JSP25-02 CAMELOT PARC TOWNHOMES

Re: Camelot Parc – PSLR Overlay Plan Revisions

PLANNING REVIEW

2nd Revised PSLR Concept Plan

AVALON PARK DEVELOPMENT, LLC
CAMELOT PARC TOWNHOMES
PSLR OVERLAY CONCEPT PLAN
CAMELOT PARC SHARED
MAINTENANCE PLANS

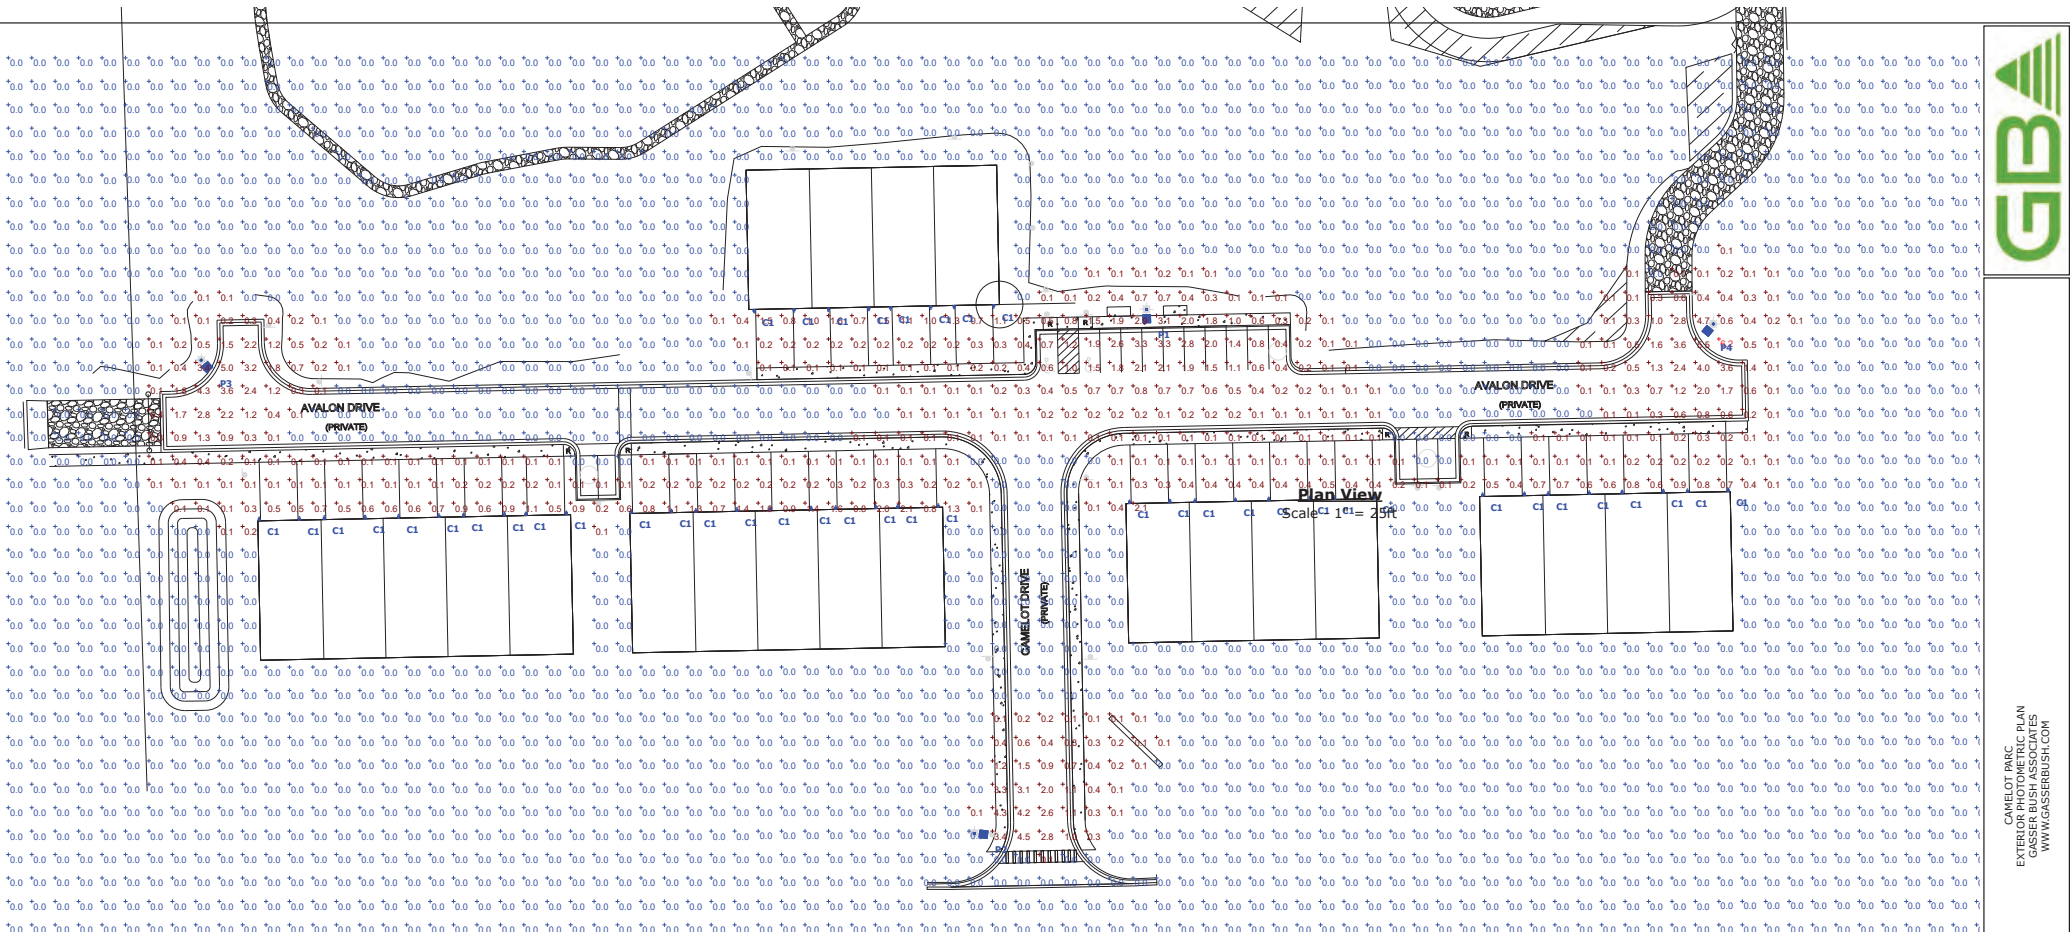
6. **Stonebrook Drive:** The applicant has included a proposed Road Maintenance Plan on Sheet 12 for Stonebrook Drive. The plan calculates a contribution for the proposed Camelot Parc toward Stonebrook Drive maintenance costs based on the length of the road, percentage of road used to access Wildlife Woods Park, and the total number of units for each development. **As Stonebrook Drive is a private road owned by Villas at Stonebrook HOA, the applicant has indicated they are discussing the road maintenance agreement with them. Any cost-sharing agreement would be a private agreement between the two entities.**

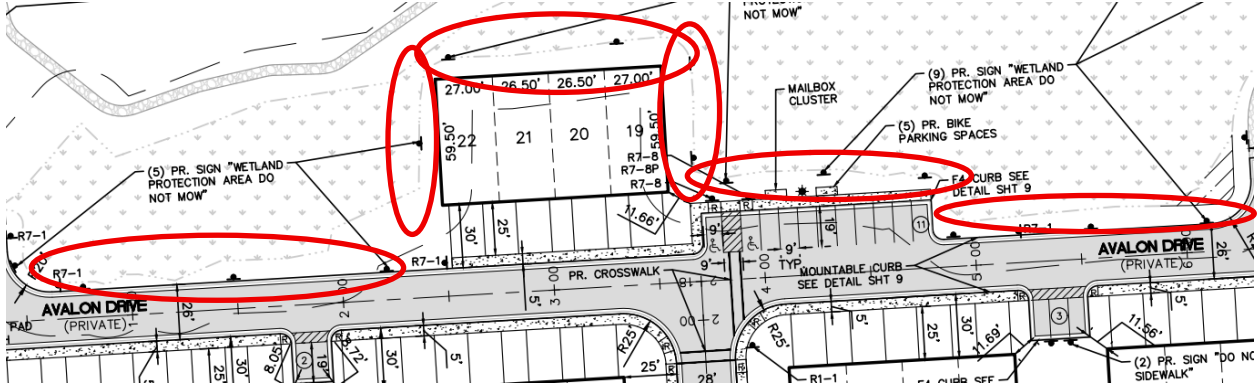
Impact	Amount
Forested Buffer	8,198 sq. ft. (0.19 acre)
Emergent Buffer	20,408 sq. ft. (0.47 acre)
Scrub-shrub Buffer	2,652 sq. ft. (0.06 acre)
Total Buffer Impact	31,258 sq. ft. (0.72 acre)

Requested edit: In future submittals, buffer impacts should be differentiated by permanent and temporary impacts (if applicable). If impacts are temporary, descriptions or sequencing should be provided showing how the temporary impacts will be restored. The temporary wetland restoration sequencing provided on Sheet 7 can be applied to any temporary buffer impacts – the header will need to be updated. Identify any temporary buffer impacts using a different symbology in the site plan.

Requested Placement locations

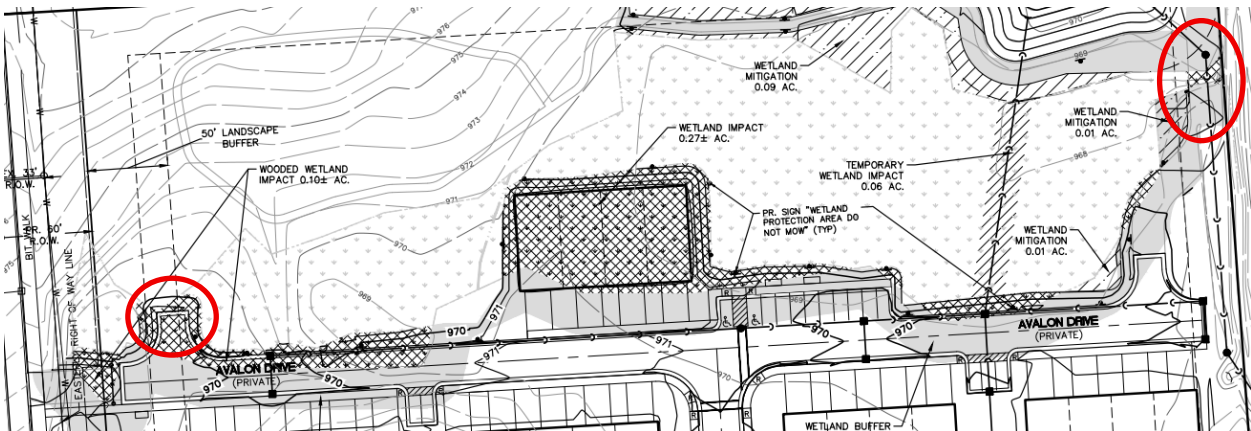
Due to the extensive proposed loss of wetland buffer along the southern remaining wetland area, it is requested that the applicant perform environmental enhancement along the southern portion of the remaining wetland (see screenshot below). The applicant should plant at least three different species of wetland rated shrubs throughout the southern boundary of the wetland. This will allow a small separation from the wetland and the proposed development. Additionally, it will deter any accidental mowing of the wetlands and remaining buffer areas. Shrubs could include three of the following species:
